Memo

Case 8576

APPLICATION FOR CLASSIFICATION AS HARDSHIP GAS WELL

Re: San Juan 29-5 Unit #89 Dakota

MLF PER MONTH

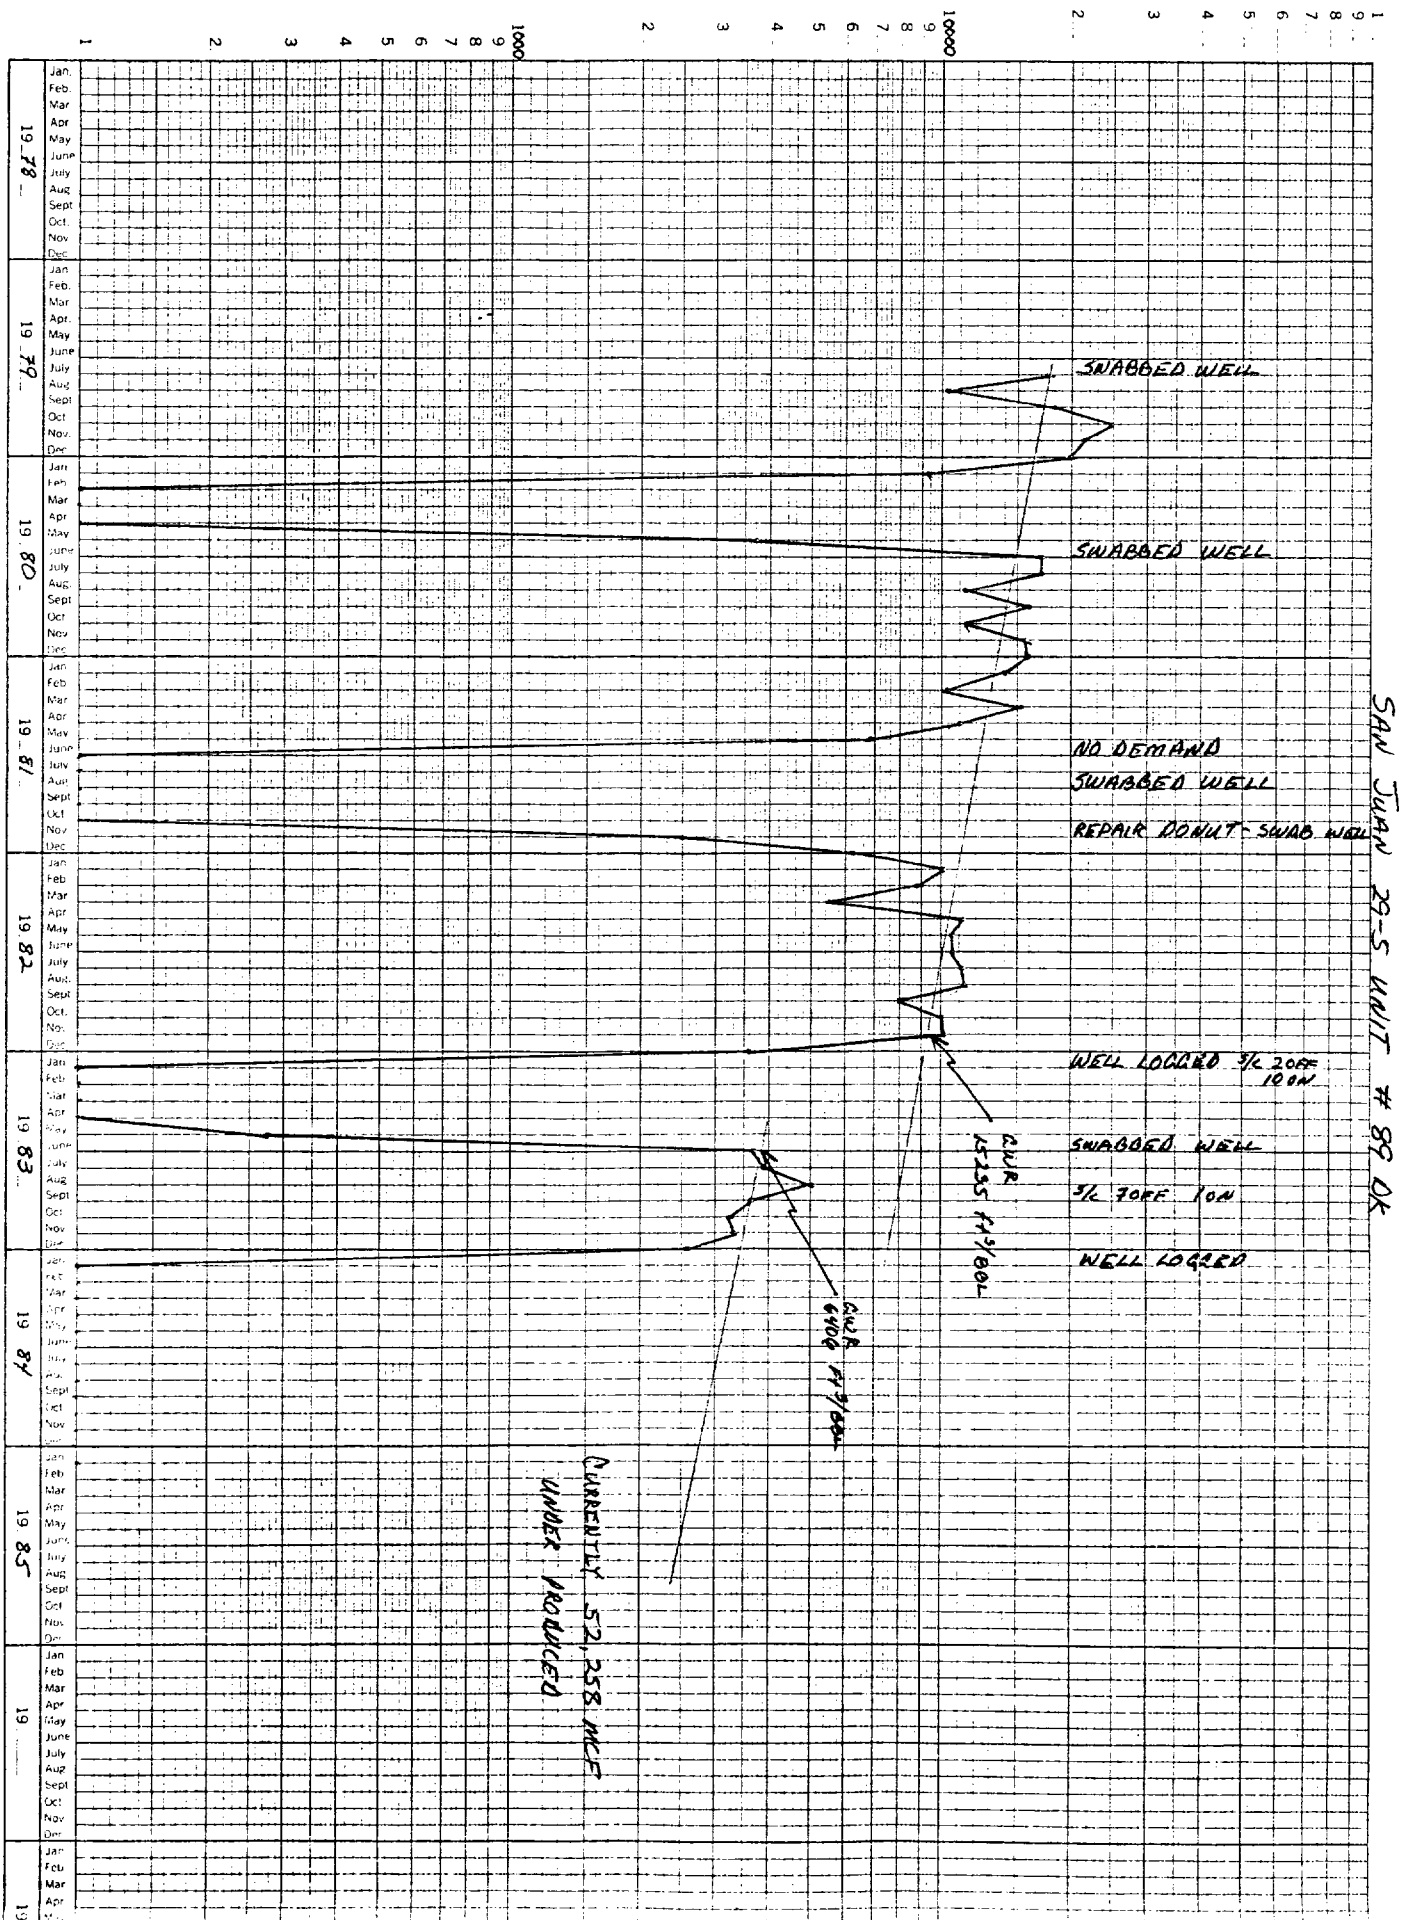
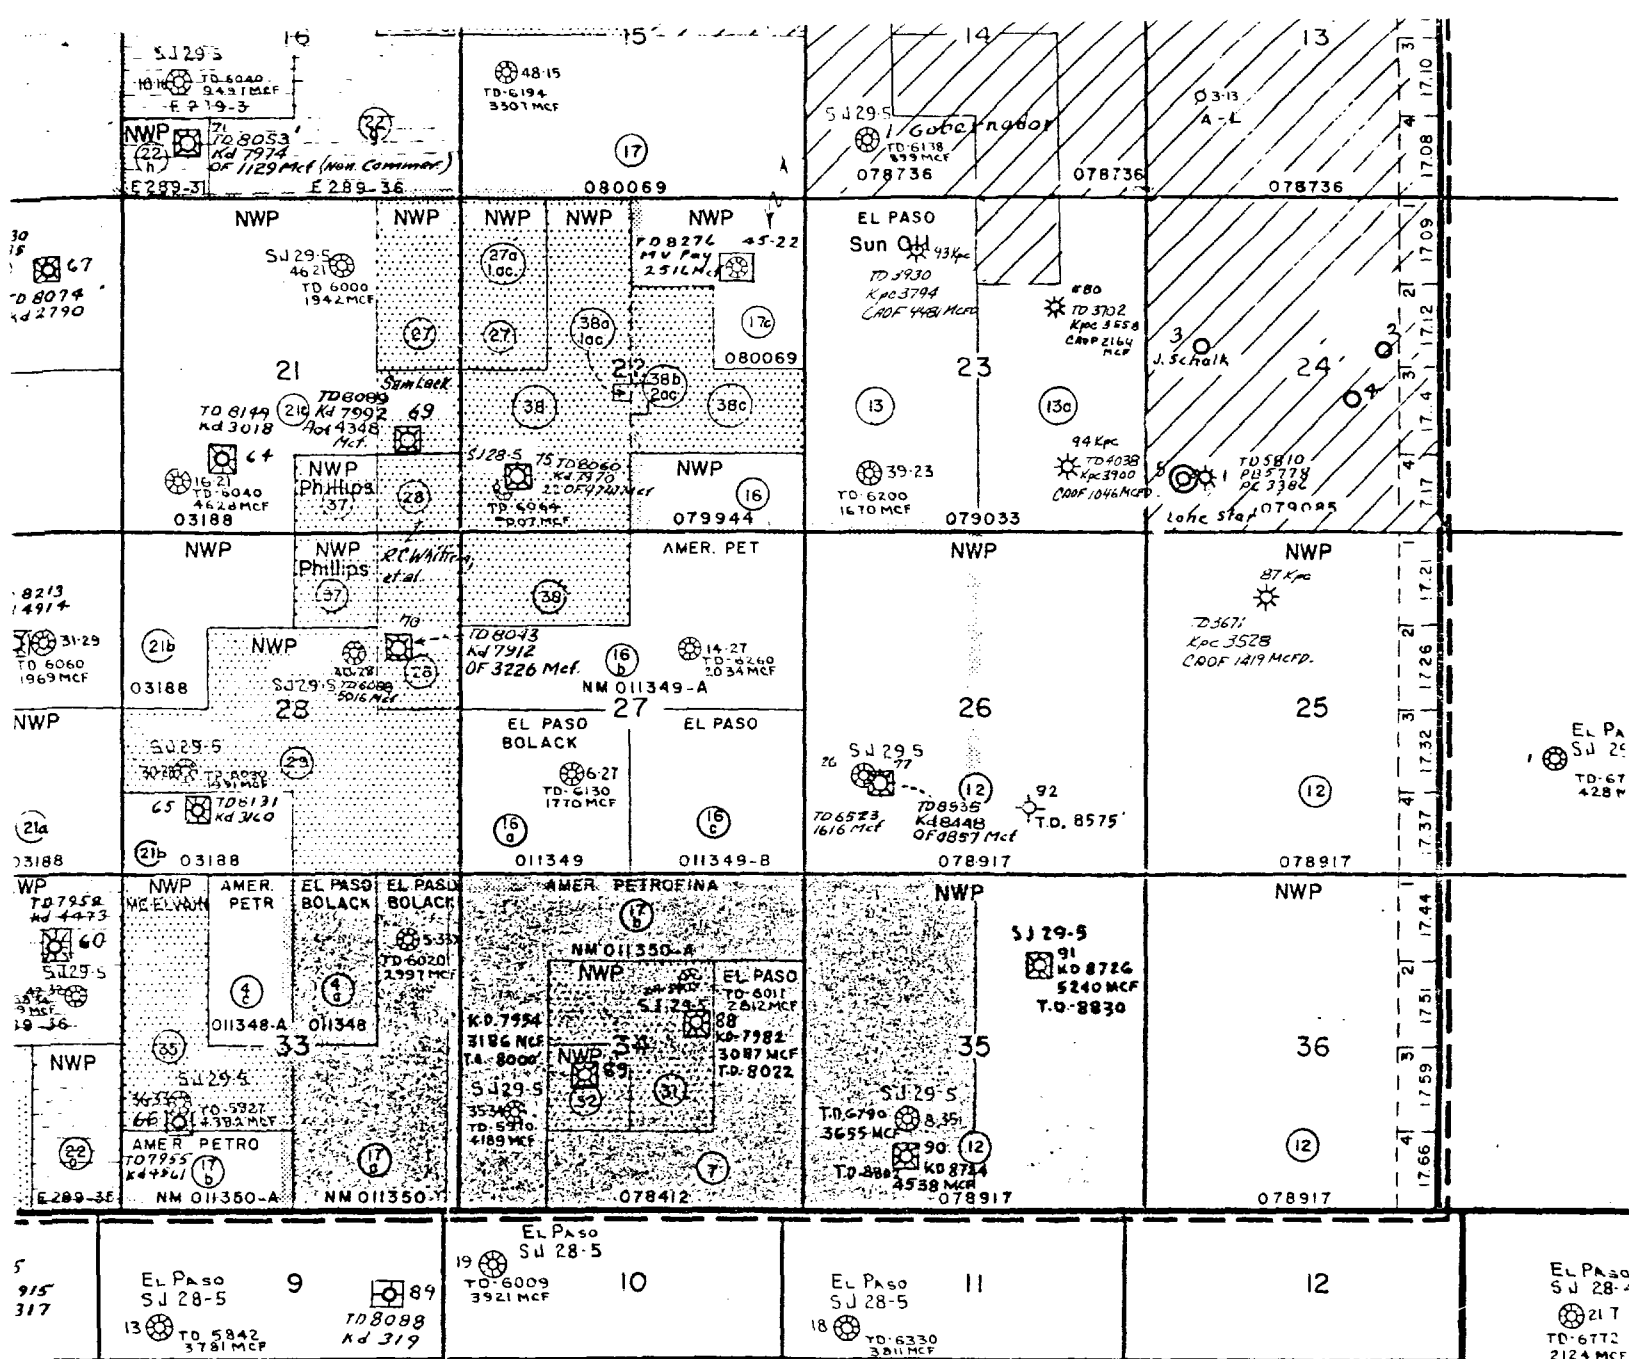
Recommend deny or locked for hearing.

- ① Smaller tubing has not been installed*
- ② Water production has never been reported on C-115's*
- ③ Declining pressure while S. I. may indicate casing failure and could account for fast production drop off.*
